RE: Riverside Center Background, Proposed Development and Project Context

RE: Riverside Center Alternative Development Scenarios

RE: Riverside Center Urban Design and City Planning Precedents

To: CB7  
 From: Michael Kwartler, FAIA  
 Date: 23 September 2009  
 RE: Riverside Center Open Space Analysis

Proposed Development/A.1, A.2 : 5 Buildings / 3 Blocks

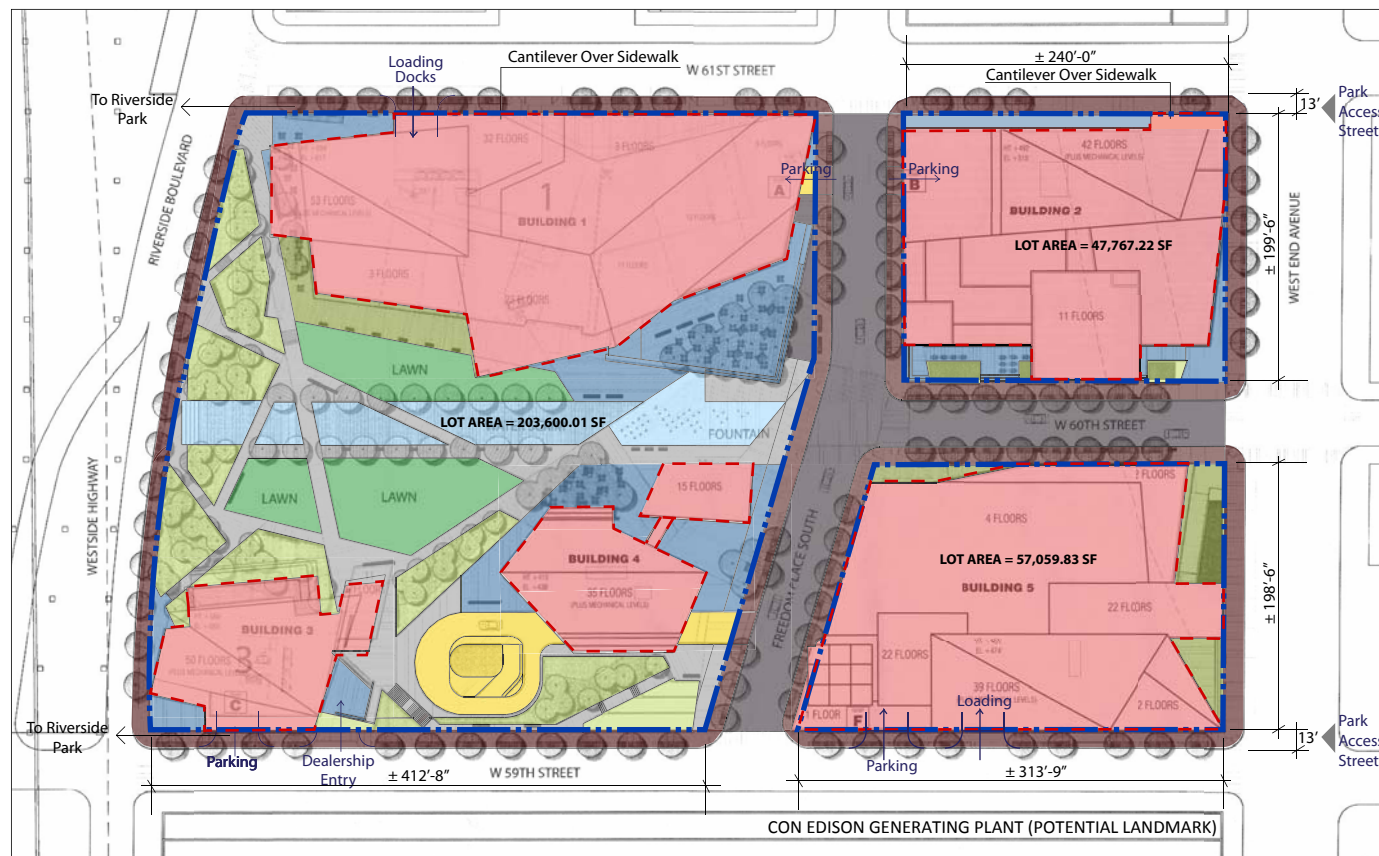
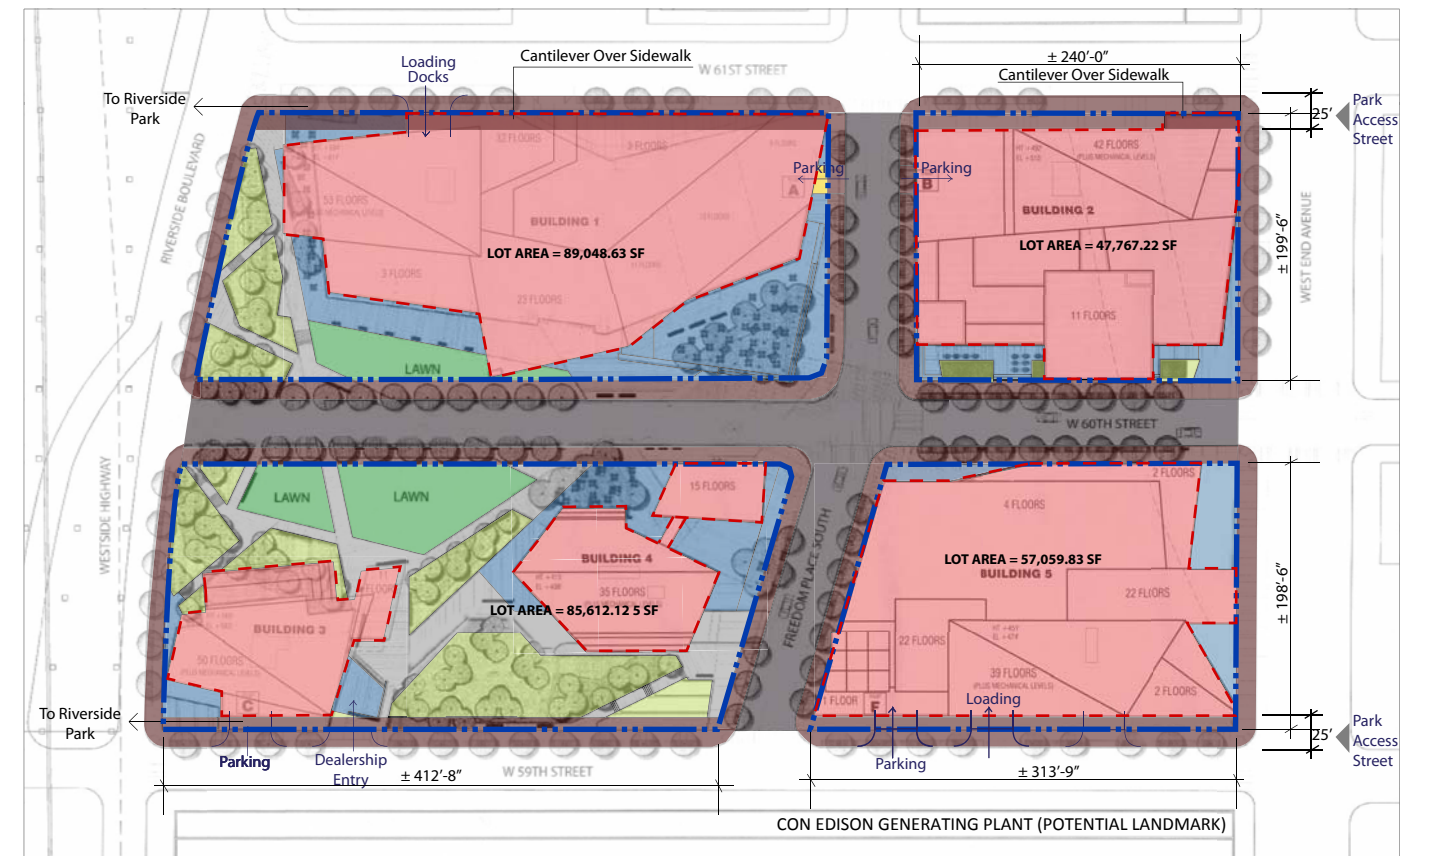
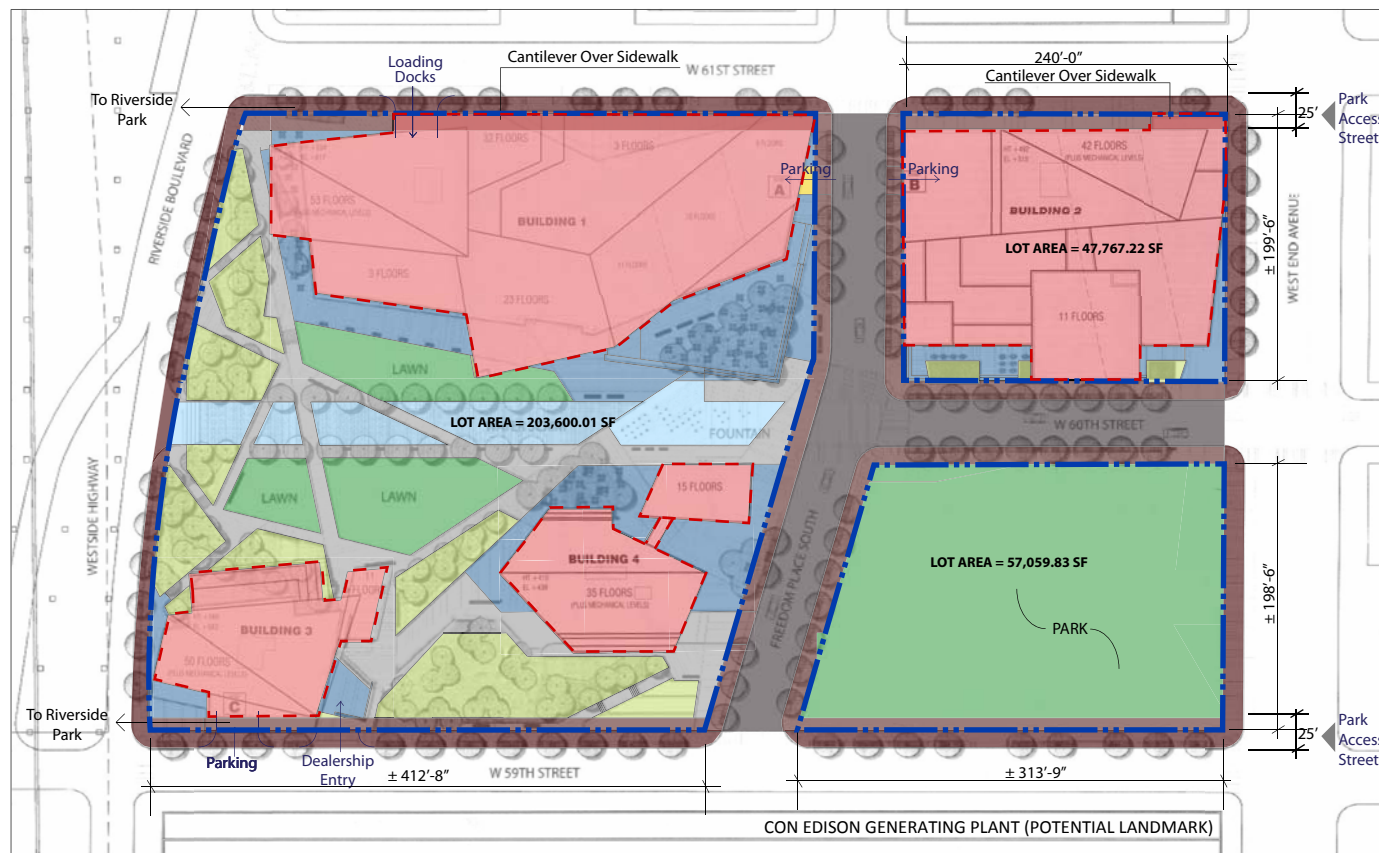
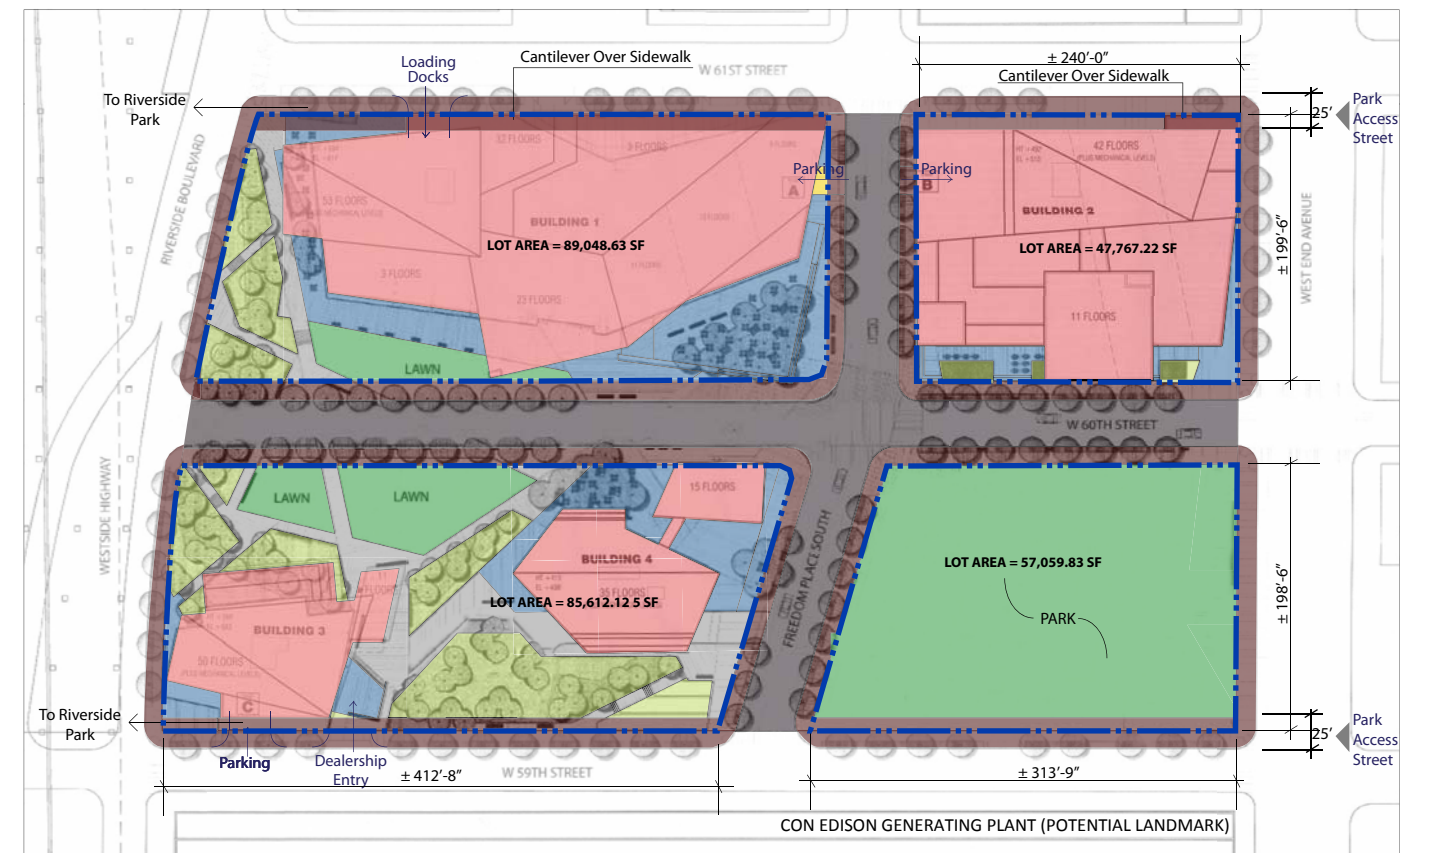
Illustrative Scenario B. creates four blocks dividing the “tower-in-the-park” superblock into two city blocks by extending W. 60<sup>th</sup> St. as a mapped city street through to Riverside Blvd. replacing the water feature and creating public streets through the site and the two sidewalk widenings along W. 59<sup>th</sup> and W. 61<sup>st</sup> streets and the bosc of trees which signals to a pedestrian access to the Riverside Sotuh Waterfront Park, is consistent with City Planning Policy (eg., Waterfront Zoning).

Illustrative Scenario C. creates a distinct publicly accessible open space similar to Manhattan West to the north fronting West End Avenue and W. 59<sup>th</sup> Street, a park access street, by removing Building #5. This results in an open space which could be completed independently from the rest of the development, and would, unlike A.1 and A.2, be in full sunlight and not be shadowed by buildings #3 and #4, and create a setting for the McKim, Meade and White Con Ed Power Plant. Scenario C. would have approximately 35% of its lot area (308,427 SF, excluding the mapped) devoted to passive open space, which is mapped, as per the Manhattan West Park, to have recreation space for children.

Illustrative Scenario D. is the most consistent with City policies. It divides the superblock into two blocks by extending W. 60<sup>th</sup> St. to Riverside Blvd. and creates a stand along the publicly accessible park similar to Scenario C. The passive open space would be approximately 37% of the lot area of approximately 279,478 SF. Similarly to Scenario C., the publicly accessible park would be in sunlight, signal Riverside South Waterfront Park access, and create a setting for the landmark-quality Con Ed Powerhouse.
